# TOTALFLOW

## *Technical Bulletin 117*

### **Analyzer Interface Unit (AIU) Upgrade Offer**

Version 1.0, Revision AB (3 June 2004)

## AIU Replacement

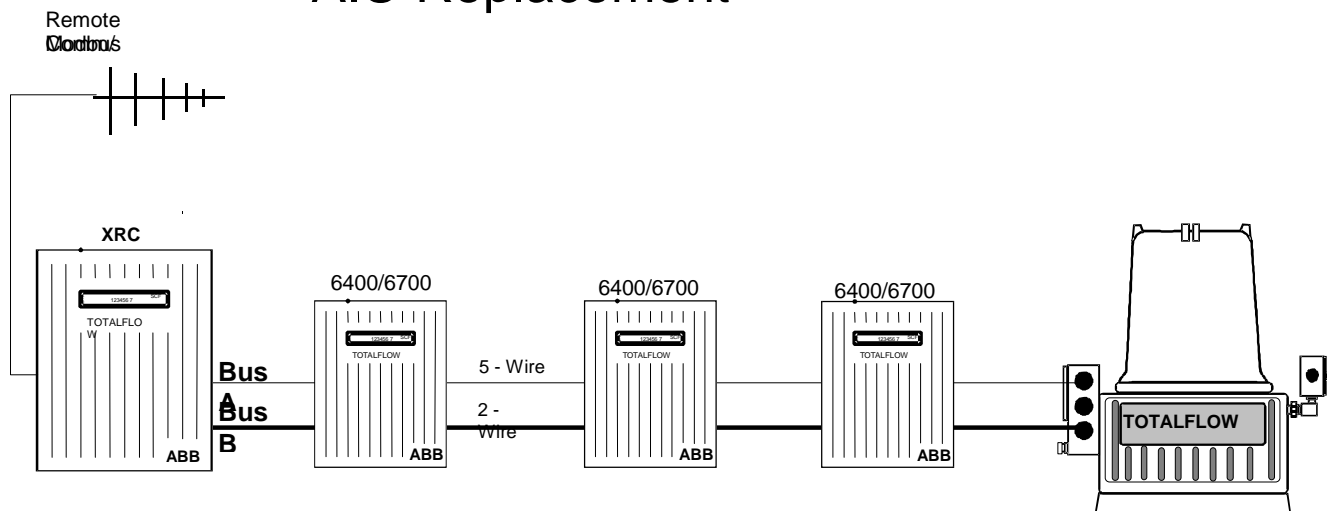
1. Replace the AIU board with the XRC replacement board. Retain and use the existing enclosure, display, power supply and communications equipment.
2. PROMS will need to be replaced in the existing 6400/6700 flow computer electronic board. Firmware support is available for the following boards (any other boards not listed will need to be upgraded):

SEE FIRMWARE UPGRADE TABLE WITHIN THIS DOCUMENT
3. Rewire the communications as depicted above. A second RS485 (BUS B) will need to be added.
  - BUS A – RS485 bus used for remote communications with the field devices (5 wire)
  - BUS B – RS485 bus used for modbus communications to manage the analysis data among the field devices.
4. BUS wiring must be performed according to the following specifications to ensure system reliability
  - All units should be connected in series as indicated in above drawing. DO NOT connect units in a star pattern.
  - The BUS should be terminated at the last device (see wiring instructions)
  - Use a high quality cable, such as Totalflow part no. 2011648-001  
RS485 cable should be foil wrapped with shield, 2 conductor size AWG 22 with nominal impedance of 120 ohms and capacitance of 22 pfd/ft. Additional conductors may be required for RTS, GND and power.
